TURKEY POINT PLANT UNIT NO. 3

Amendment No. 58
License No. DPR-31

AMENDMENT NO. 58 TO FACILITY OPERATING LICENSE NO. DPR-31

SAFETY EVALUATION BY THE OFFICE OF NUCLEAR REACTOR REGULATION
RELATED TO AMENDMENT NO. 58 TO FACILITY OPERATING LICENSE NO. DPR-31
AND AMENDMENT NO. 51 TO FACILITY OPERATING LICENSE NO. DPR-41

Figure 3.2-3

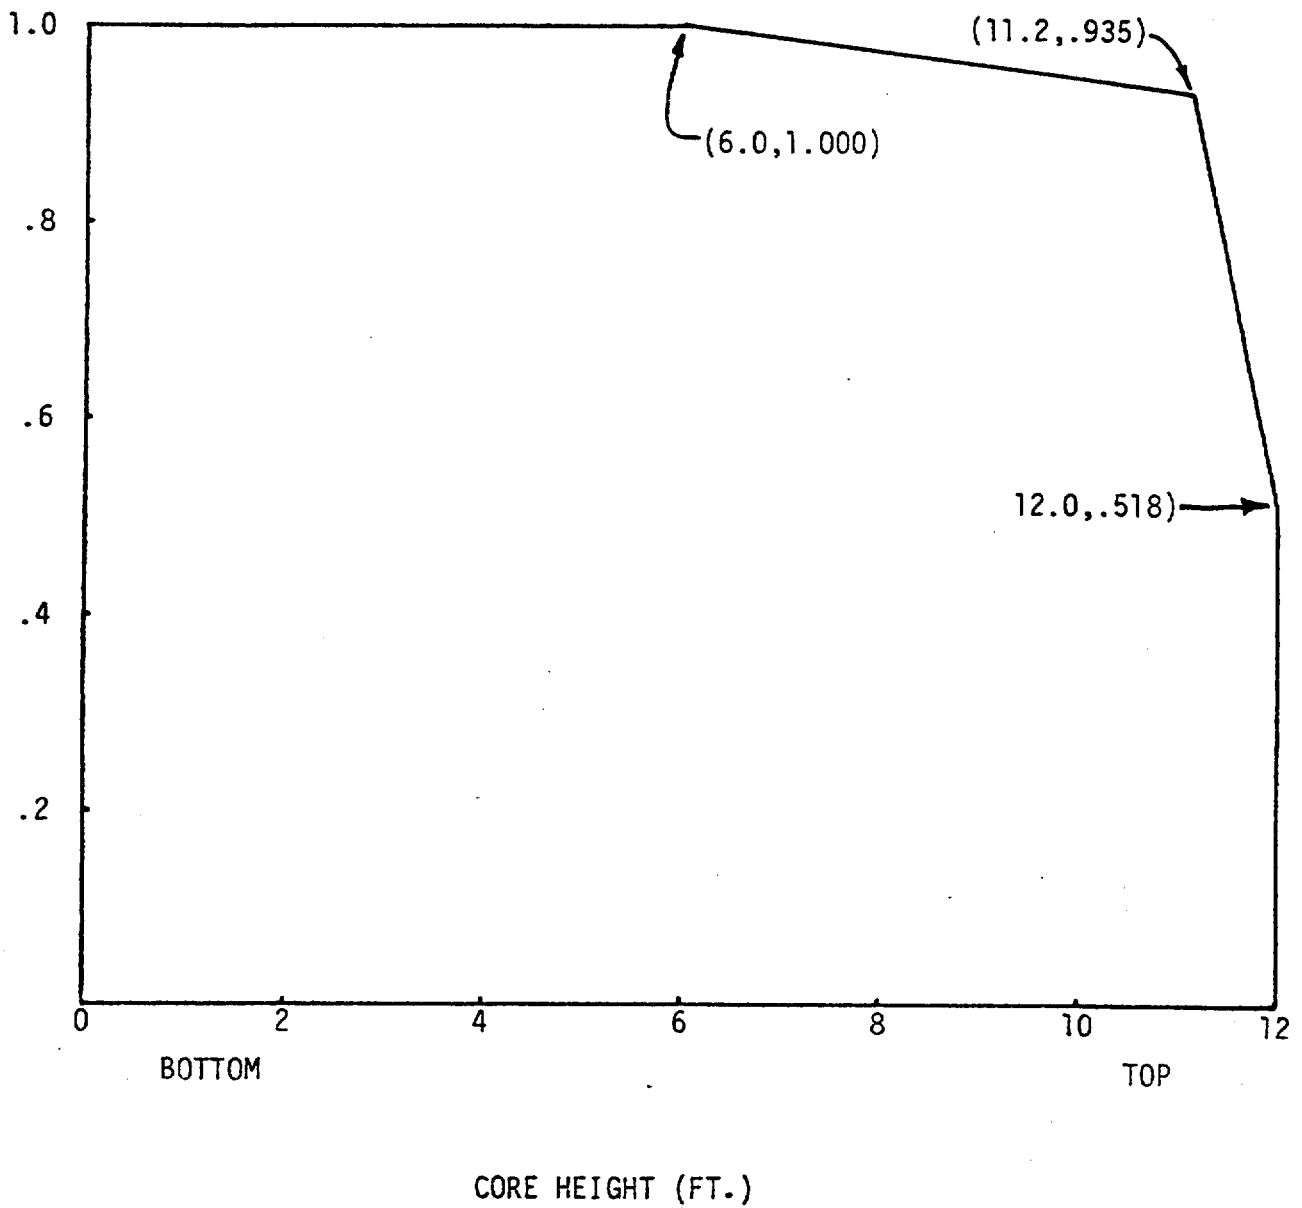
<u>Remove Pages</u>	<u>Insert Pages</u>
3.2-3	3.2-3
3.2-4	3.2-4
Figure 3.2-3	Figure 3.2-3
3.2-3a	
3.2-3b

Where P is the fraction of rated power at which the core is operating; K(Z) is the function given in Figure 3.2-3; Z is the core height location of F_q .

HOT CHANNEL FACTOR
NORMALIZED OPERATING ENVELOPE

(for $\leq 25\%$ steam generator tube plugging and $F_q=1.93$)

HOT CHANNEL FACTOR
NORMALIZED OPERATING ENVELOPE

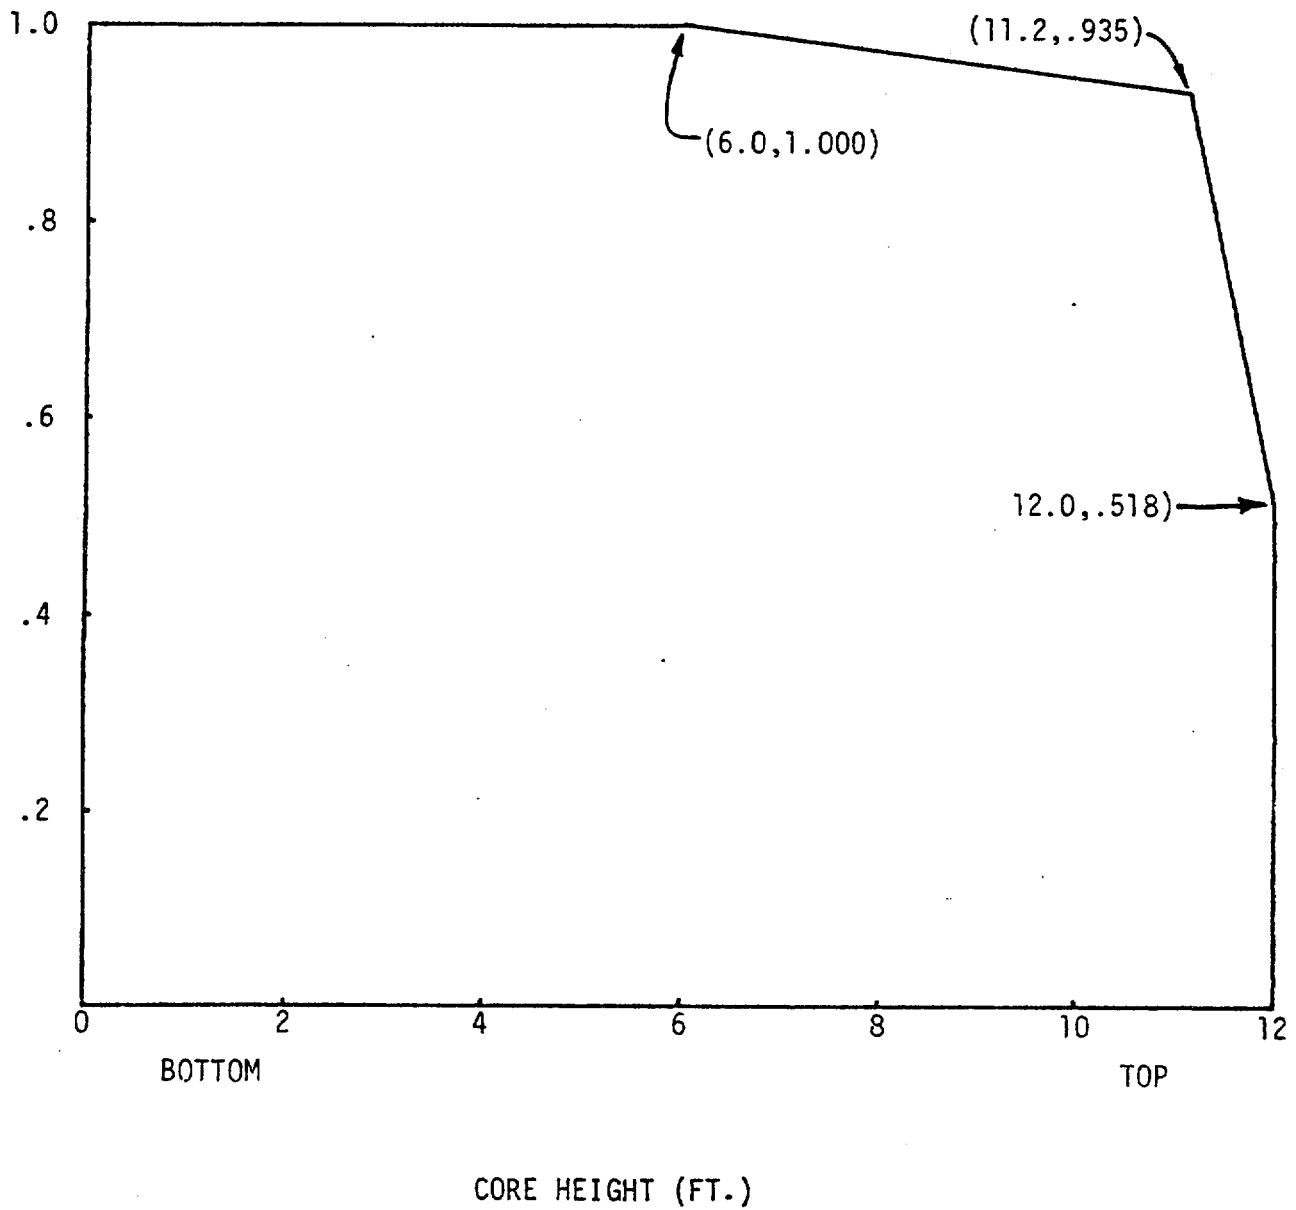
3.2-3
3.2-4
Figure 3.2-3
3.2-3a
3.2-3b

3.2-3
3.2-4
Figure 3.2-3

Where P is the fraction of rated power at which the core is operating; K(Z) is the function given in Figure 3.2-3; Z is the core height location of F_q .

(for $\leq 25\%$ steam generator tube plugging and $F_q=1.93$)
